Petition No. 1220
Interrogatories
Set One
April 4, 2016

Windham Solar LLC (WS) Responses April 18, 2016

VOLUNTOWN RD. SOLAR
 1219 & 1240 VOLUNTOWN RD.
 GRISWOLD, CT 06351
 NEW LONDON COUNTY

OVERALL SITE PLAN

Exhibit A
PID MAP

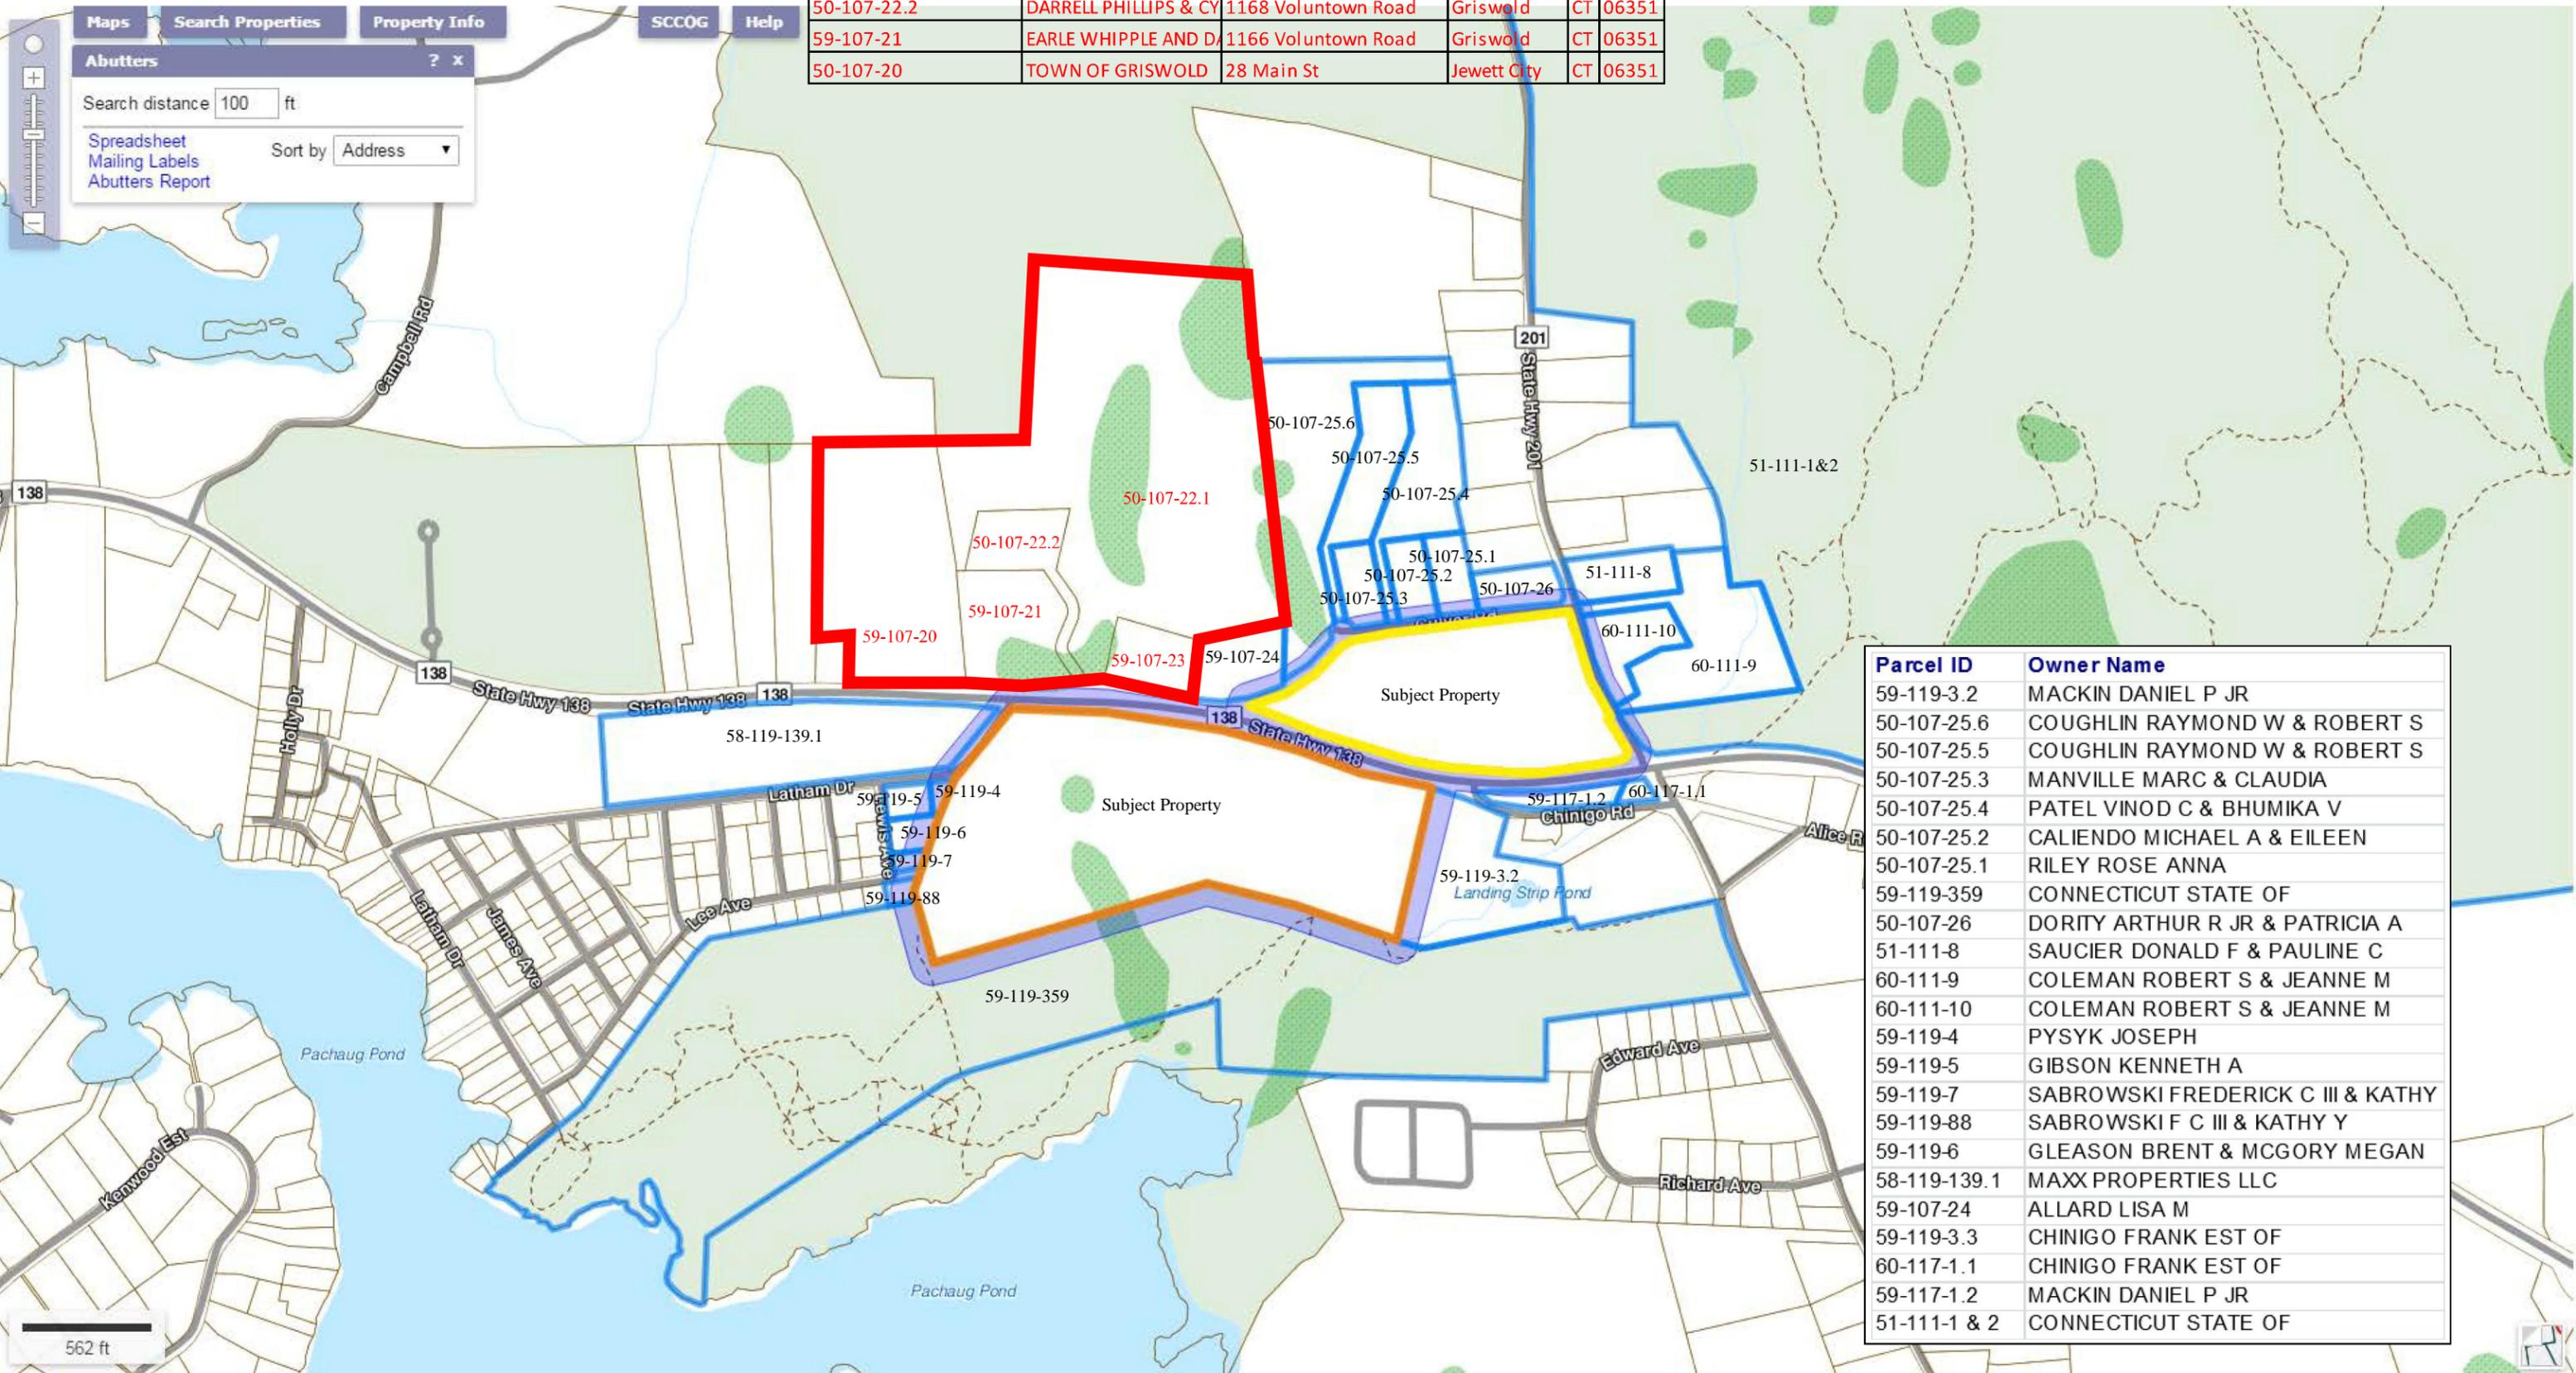
1. Windham Solar LLC (WS) included an abutters map under Exhibit D of its Petition (Petition) dated March 15, 2016 for the proposed project in Griswold. Please submit a properly-labeled abutters map identifying each parcel owner, including but not limited to, the abutters listed in Exhibit D of the petition.

A revised Map has been attached identifying parcels, and the associated owners. – Exhibit A

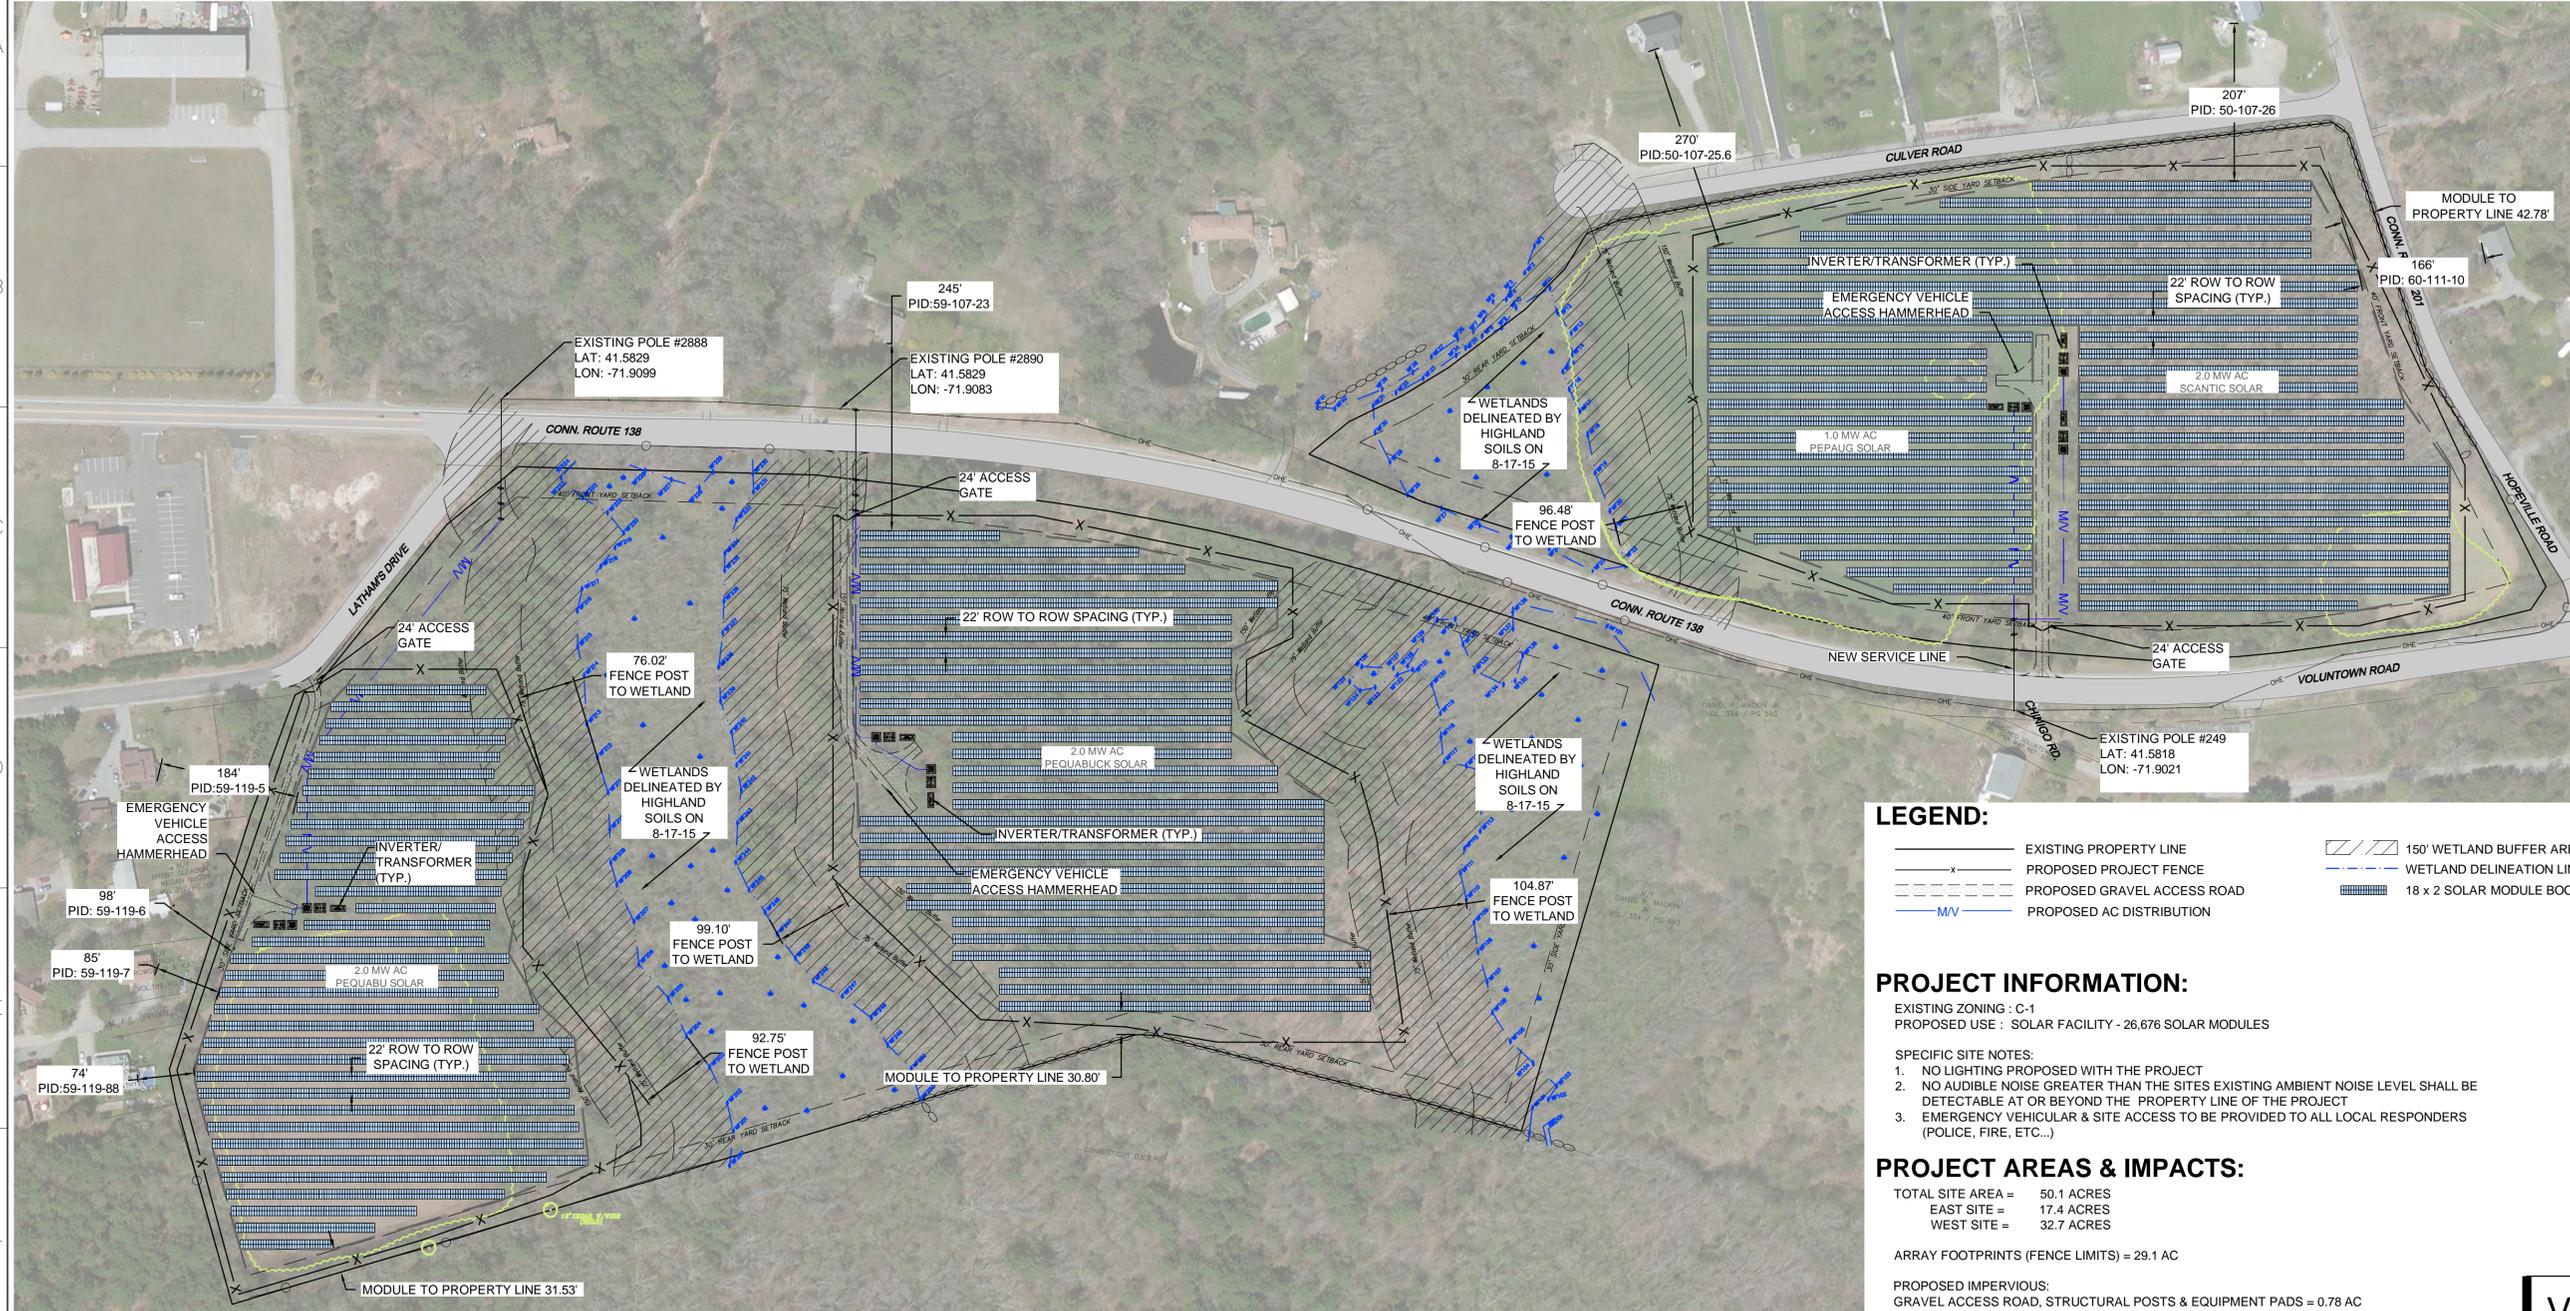
3. Where is the nearest off-site residence from the center of the eastern portion of the project? Provide the distance, direction, and address of such off-site residence. Where is the nearest off-site residence from the center of the western portion of the project? Provide the distance, direction, and address of such off-site residence.

5. Indicate which solar arrays on the Overall Site Plan (Sheet 4 of 12) are the 2 MW arrays and which array is the 1 MW array.

21. What is the closest distance from the proposed project to wetlands (i.e. the smallest wetland buffer)? (For example, see the eastern-most corner of the southwest array on the Overall Site Plan – Sheet 4 of 12).
Dimensions have been added to the site plan which indicate the distance to nearby wetlands.
– Exhibit B

The overall site plan has been revised to show dimensions from the homes to the closest modules to the facility and parcels are identified. – Exhibit B

Boundaries have been added to the overall site plan, illustrating each array area. – Exhibit B

INVERTER SKID PLAN AND PROFILE

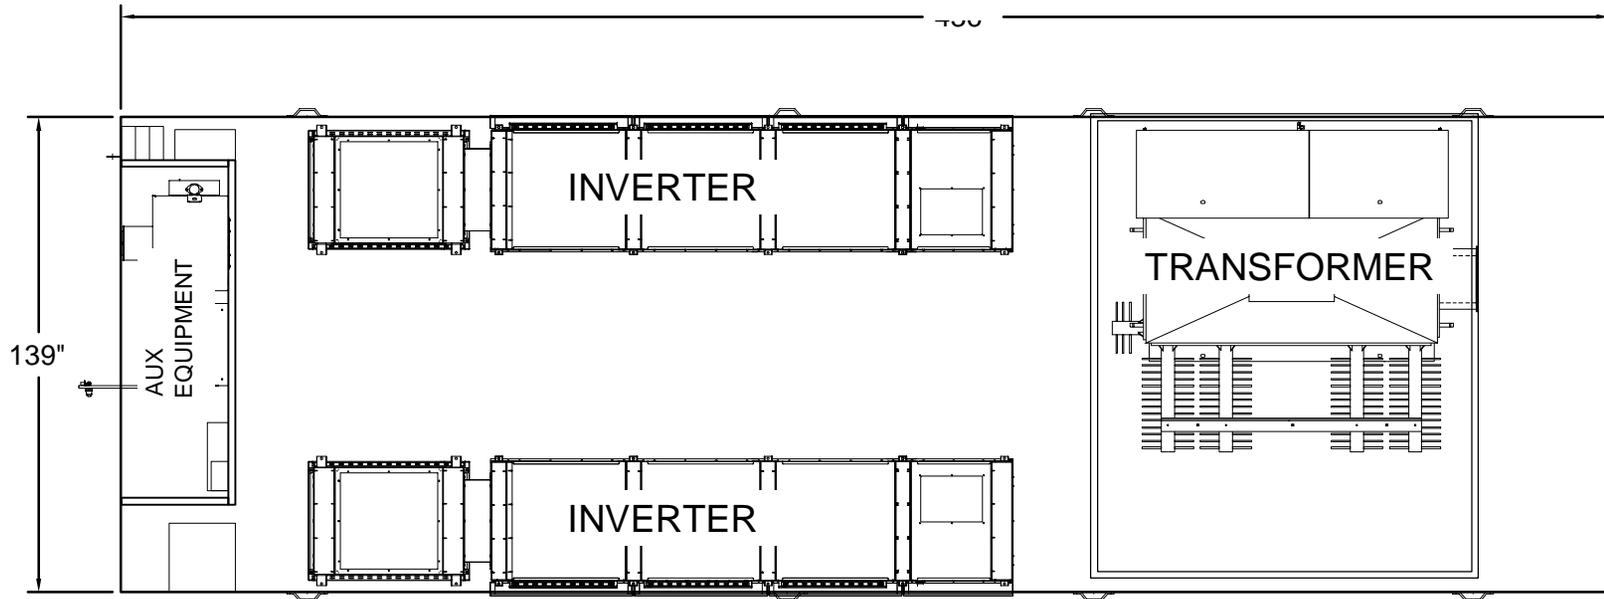
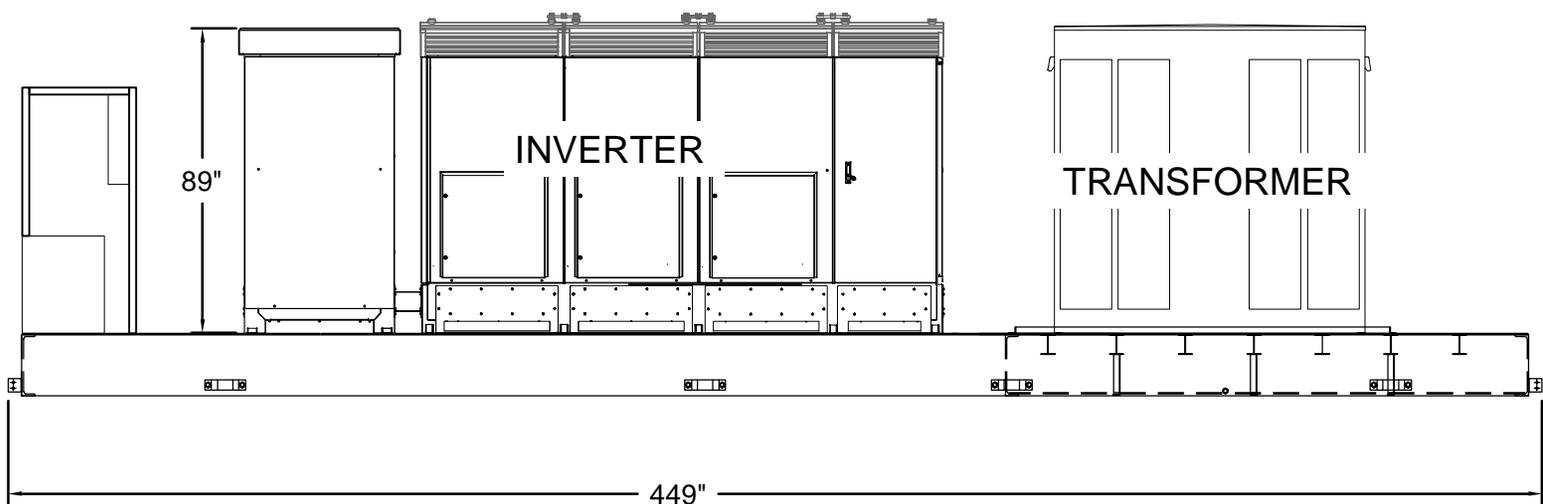
13. What are the estimated heights of the transformers and inverters?
The transformer is approximately 7' high.
The 1,000 kW centralized inverter is approximately 7' high. The 60 kW string inverters would be mounted at a height of approximately 5' – 6' high and be located throughout the array field. A cut sheet of a typical inverter/transformer pad has been added (2-1000-kilowatt inverters and 1 2000KvA transformer) – Exhibit E

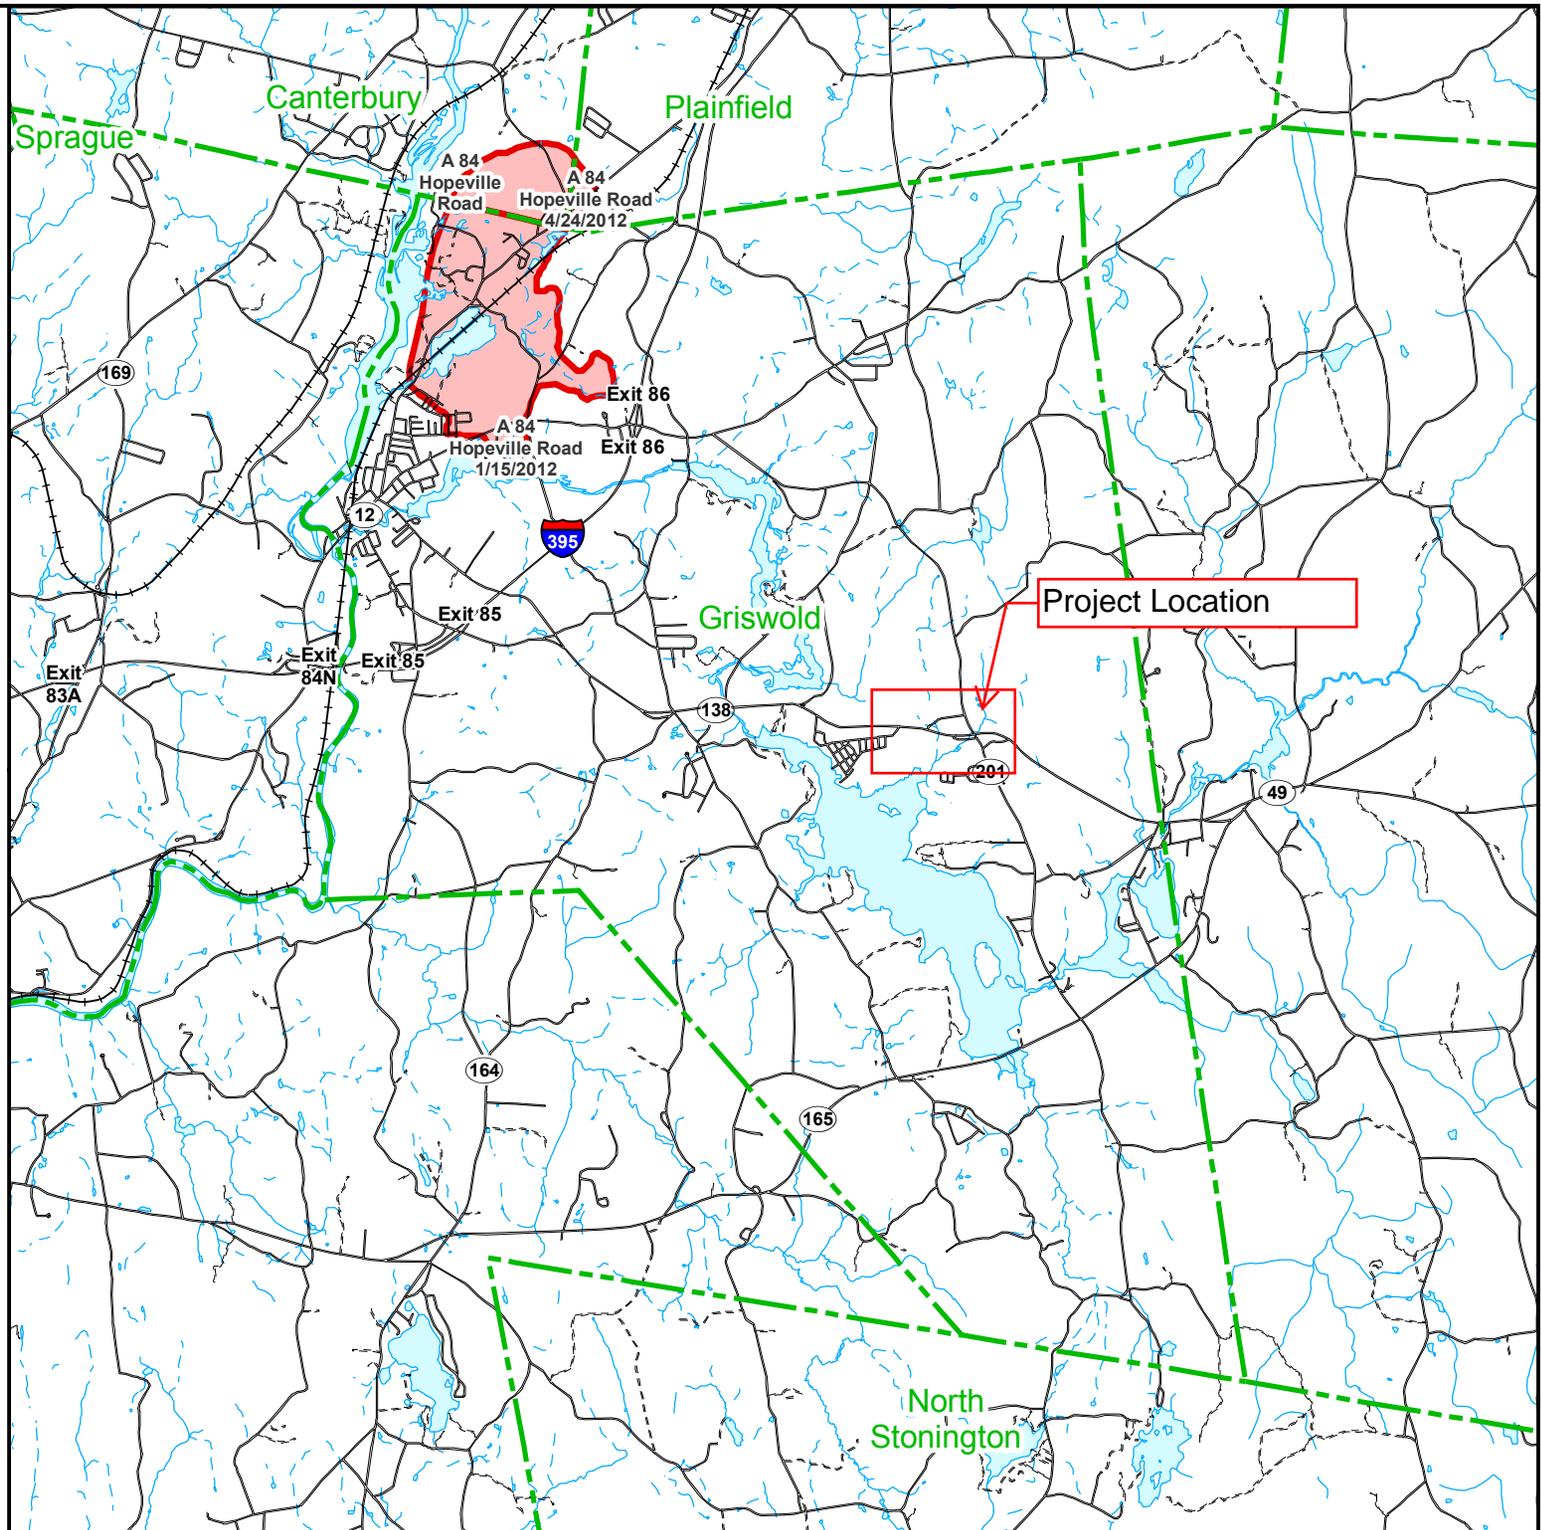
27. Is the proposed project located within an aquifer protection area?

No, an aquifer protection map has been attached. - Exhibit F
